JGN Gas Network
CCP31 Advice to the Australian Energy Regulator
AER Draft Decision (November 2024) and JGN Gas Networks NSW
Revised Access Arrangement Proposal (January 2024)

Consumer Challenge Panel (CCP) Sub-Panel CCP31

14 February 2025

Figure 4-1: Accelerated depreciation options tested in the customer survey¹⁸

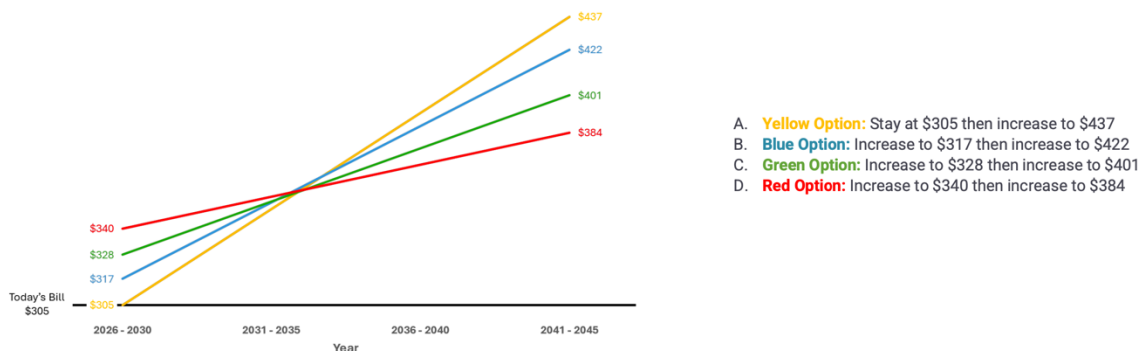
CCP31 has reviewed the Sagacity report, and we have met with JGN to discuss our concerns and ensure we have the correct information to inform this advice. We thank JGN for meeting with us to discuss the survey and other issues. We remain sceptical over JGN's survey evidence to support its accelerated depreciation proposal. The key points are listed below:

- We understand the sample was selected from online panels, and it is not evident in the published report that the sample is representative across JGN's five service regions. The consultant has since provided an analysis of the sample into statistical areas and reports that 246 of the 228 JGN postcodes were included in the sample. Whilst we appreciate this detail, we are not clear as to which customers (by post code or statistical local area) were excluded and whether their exclusion constitutes a bias in the sample.

- In JGN's June 2024 *Access Arrangement Proposal*, the Advisory Board describes accelerated depreciation as "complex subject matter"²² and CCP31 agrees. A wholesome and objective discussion of the subject needs to consider whether customers consider they should pay, the alternatives and the implications in the context of the overall bill impact. We question whether simplifying the description of accelerated depreciation (as it relates to a regulated monopoly asset required to deliver an essential service) to a vendor deciding how to recover the cost of a discretionary purchase of a coffee machine provides an accurate description of the subject matter. This was a very useful analogy, but lacked some the necessary nuance.

Figure 4-2: Biomethane supply curves, 2030, 2040, 2050

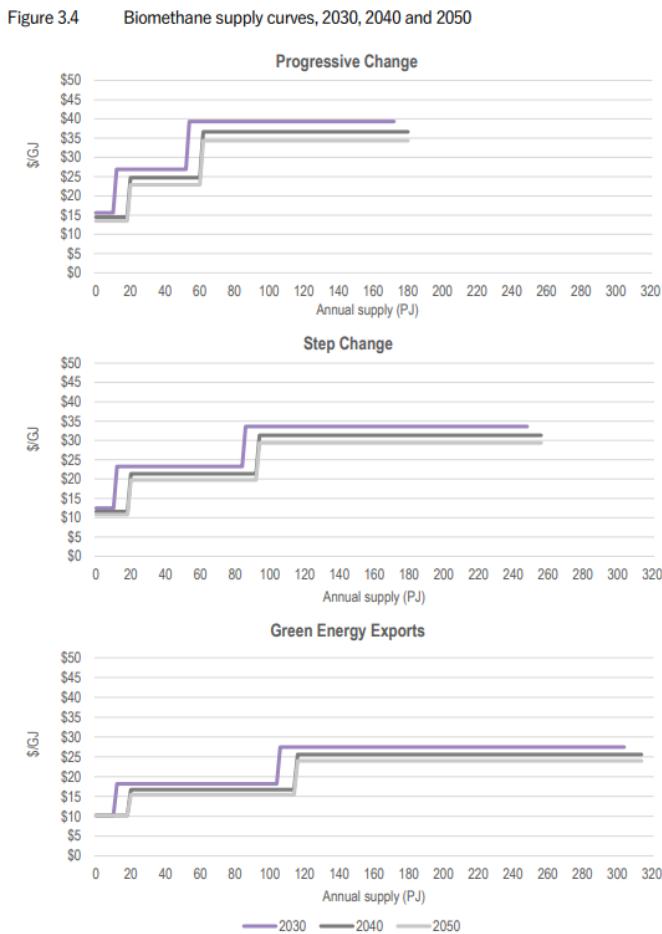
CCP31 is also concerned about the volume of biogas that can be produced, and the cost of biomethane. AEMO’s *Draft 2025 Inputs, Assumptions and Scenarios Report*²⁹ includes an appendix prepared by ACIL Allen which contains gas, liquid fuel, coal and renewable gas projections,³⁰. This report provides estimates for biomethane supply curves, to 2050 for the three scenarios used for the Integrated System Plan (ISP), as shown in the following figure:

We note that *progressive change* and *step change* scenarios were regarded as the most likely future scenarios for the 2024 ISP. The ACIL Allen projections referenced in the report show that the price for biomethane rises with volume produced. Excluding the less likely Green Energy Exports scenario, biogas is forecast to cost between \$35 and \$40 per giga joule at volume, compared to \$14-\$16 per giga joule for natural gas.

Figure 4-3: Comparison of demand forecasts

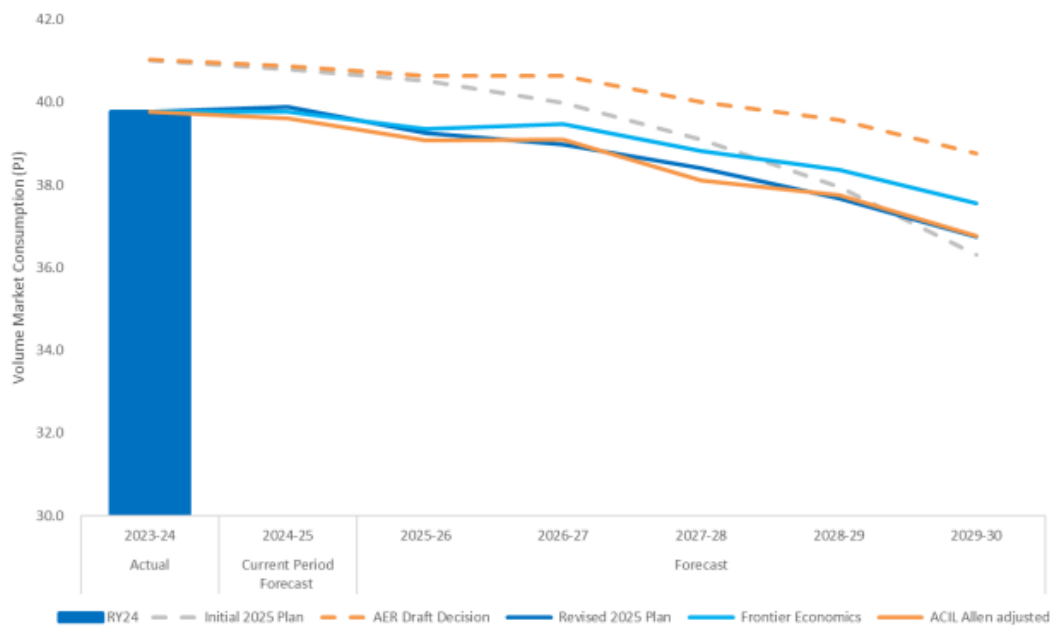
The differences in forecasts over a relatively short period reflect the uncertain future for gas and the challenge in forecasting demand in an uncertain future. This has been a consistent theme in our advice to the AER related to this access arrangement and we have encouraged JGN to revise its forecasts as close to the AER making its final decision.

Deciding on a ‘best’ forecast has become akin to a duel between three consultants: JGN engaged CORE and Frontier Economics, while the AER engaged ACIL Allen. In the *Revised Plan*, JGN compares the forecasts as follows:³⁸

Figure 4-4: JGN’s Revised Plan price path

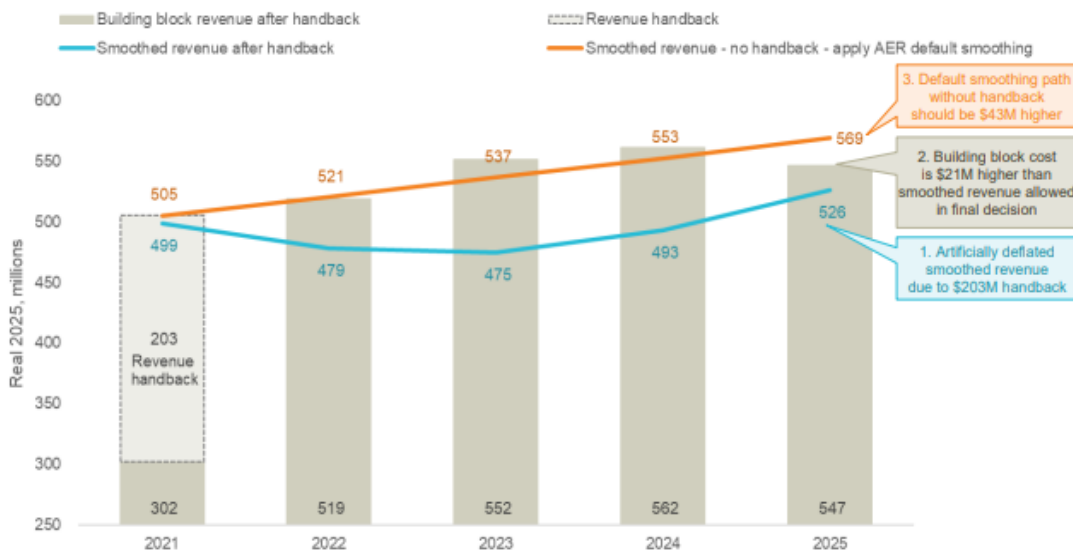
The main question associated with JGN’s *Revised Plan* price path relates to the base price with 2021 being the year that JGN returned \$203m of revenue to customers as a rebalancing from the remitted decision of 2015-20. JGN is arguing that the AER’s draft decision AER artificially deflated smoothed revenue due to the \$203m handback. In response, JGN presented a revised, higher price path in Attachment 7.2 of the 2025-20,⁴³ reproduced here.

JGN states that they consider 2024-25 revenues to be deflated from efficient building block costs by \$43m as shown in the following figure.⁴⁴ This means that the base year for projecting current and hence next period revenues is too low. The price path for 2025-30 should start \$43m higher.

We expect that this would result in a better outcome for customers with a price path between JGN’s *Revised Plan* proposal and the AER’s *Draft Decision*.

Figure 4-5: JGN’s building block revenue requirement 2015-30

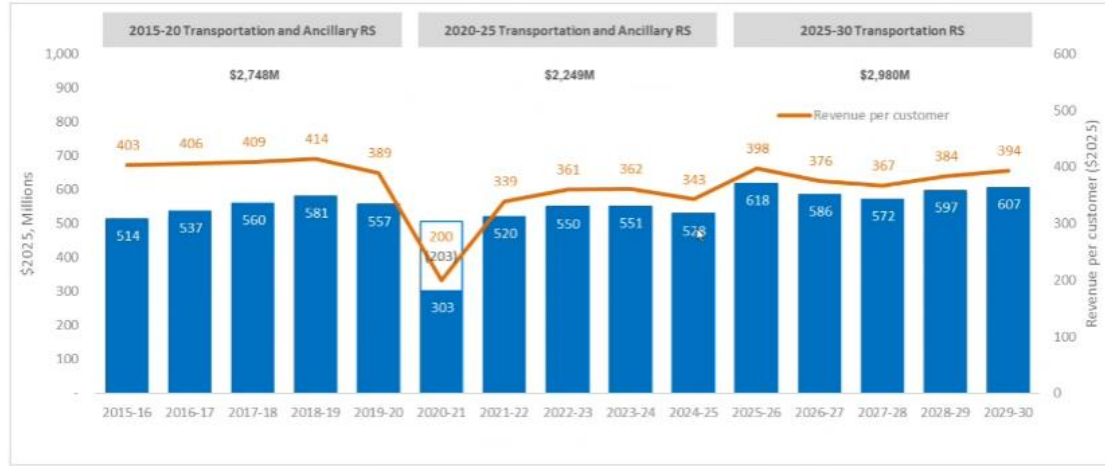
CCP31 appreciates JGN’s argument and recognises the dilemmas of the remitted decision on 2020 - 2025 revenue. However, we ask whether JGN is overstating the impact of one year (2021) when a more reasonable approach would look at setting a basis for 2025-30 price path based on averaged revenue for the previous and current period, smoothing out the outlier year of 2021 to reflect a more realistic revenue requirement.
